Project: IEEE P802.15 Working Group for Wireless Personal Area Networks (WPANs)

Submission Title: [**Comment resolution on sensitivity definition and frame length field**]

Re: [In response to comment on TG4g FSK draft]

Abstract: [SFF comment resolutions]

CID#7: Frame Length Field

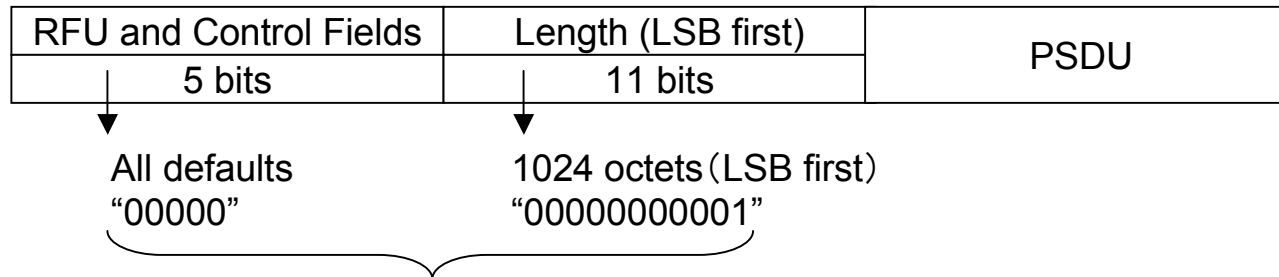
Comment: Proposed text (from SFF) below is missing;
"In the case of the MRFSK PHY, the Frame Length field shall be formatted with the MSB to be transmitted first."

- add "In the case of the MRFSK PHY, the Frame Length field shall be formatted with the MSB to be transmitted first."

- Average number of consecutive zeros or ones are smaller (next slide)
- PHR will be formatted in octet-wise in practical implementation
 - 11 bit frame length field will be split into 2 octet fields
 - It seems reasonable 3 bits represents more significant bits (in the first octet) and 8 bits represents less significant bits (in the second octet)

Back-up: Frame Length Field

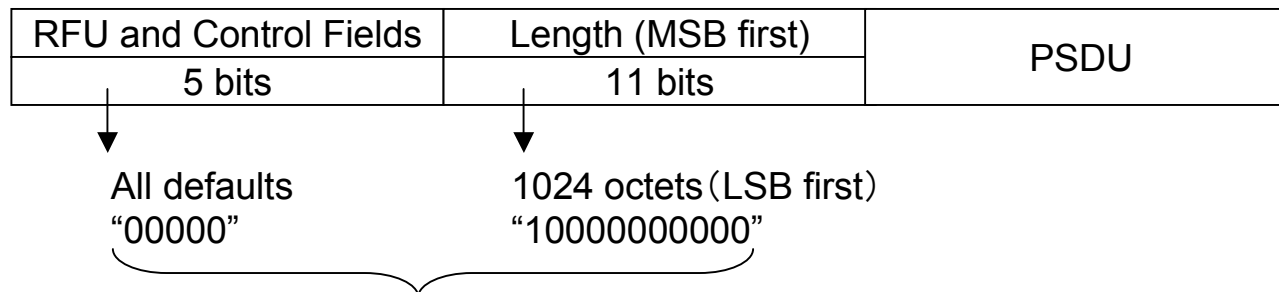
- Currently, PHR scrambling / non-scrambling is possible
- Should avoid transmitting / receiving continuous “0”s or “1”s, which could lead to bit error in FSK modem

15 bits of continuous “0”s -> should be avoided

10 bits of continuous “0”s

**-> average # of consecutive zeros will be smaller
as we do not have PSDU length of 0, ..., 4**
